# UNITED STATES PATENT AND TRADEMARK OFFICE

APPLICATION NO.	FILING DATE	FIRST NAMED INVENTOR	ATTORNEY DOCKET NO.	CONFIRMATION NO.
10/017,924	12/07/2001	Hsin-Hong Huang	10541/775	1505
29074	7590	05/18/2004	EXAMINER	
VISTEON C/O BRINKS HOFER GILSON & LIONE PO BOX 10395 CHICAGO, IL 60610			GARCIA, ERNESTO	
			ART UNIT	PAPER NUMBER
			3679

**Office Action Summary**

## DETAILED ACTION

Fig. 10

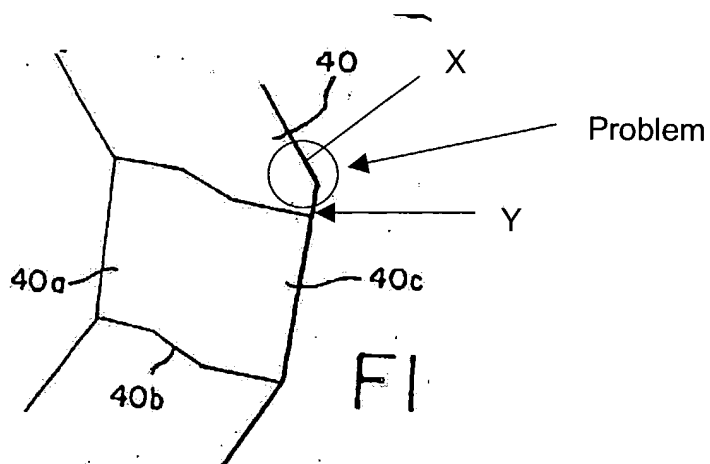
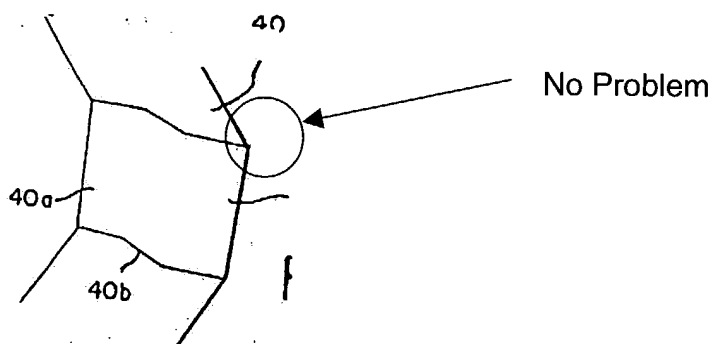
A drawing was received on 2/17/04. This drawing includes changes acceptable as the drawing overcomes the objections stated in the final office action. However, due to further review and understanding of the invention, Figure 10 has a discrepancy as follows.

The drawings are objected to because Figure 10 is out of proportion in respect to the line X, as shown in the attachment A provided herein, not joining at the intersection Y. The examiner has provided what Fig. 10 should be.

Fig. 10 should be

Fig. 7

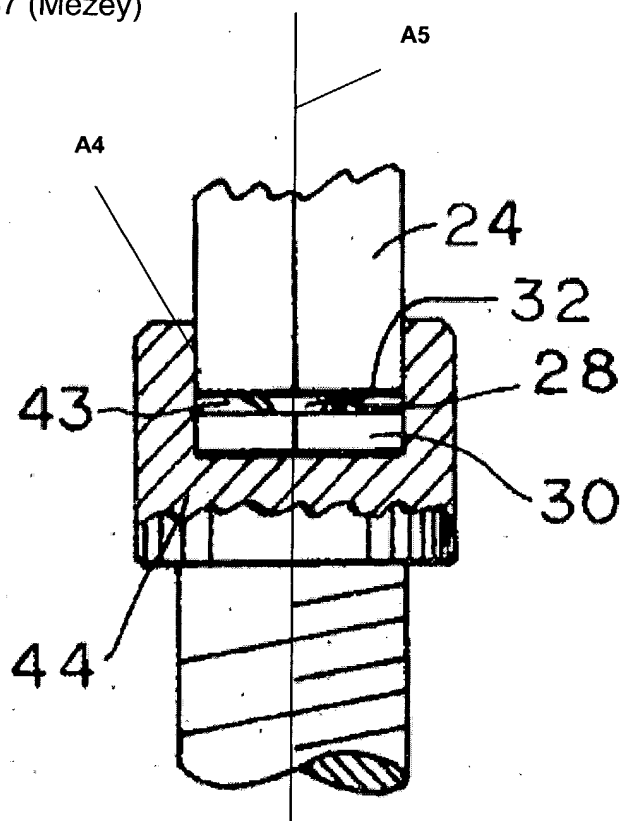
Regarding claim 1, Mezey discloses, in Figure 7, an interface between a driving member **24** and a driven member **44**. The driving member **24** has a polygonal length **38** having at least one surface selected from a group consisting concave and convex surfaces. The driven member **44** has a matching polygonal length **A4**. The polygonal length **38** or the matching polygonal length **A4** includes a twisted portion **30** twisted along an axis **A5** of the polygonal length **38** or the matching polygonal length **A4**.

However, Mezey fails to disclose the polygonal length **38** having at least one surface selected from a group consisting concave and convex; and, the twisted portion **30** being twisted from 10' to one degree. Mezey suggests that other configurations of the interface can be made (col. 3, line 50 to col. 4, line 2). Therefore, one applying the invention to Torx heads or sockets will find that the polygonal length will include a concave polygonal length. Furthermore, it would have been obvious matter of design consideration to make the twist at different degrees as being dependent on the gap between the driving member and the driven member. Mezey is concerned with slippage thus a small gap between the untwisted part in the interference will require a lesser amount of twist to prevent slippage as a result of the torque the twisted portion applies to the matching polygonal length. Therefore, as taught by Mezey, it would have been obvious to one of ordinary skill in the art at the time the invention was made to make the twist twisted from 10' to 1 degree to prevent slippage at lesser gaps between the untwisted portion of the driving member and the driven member.
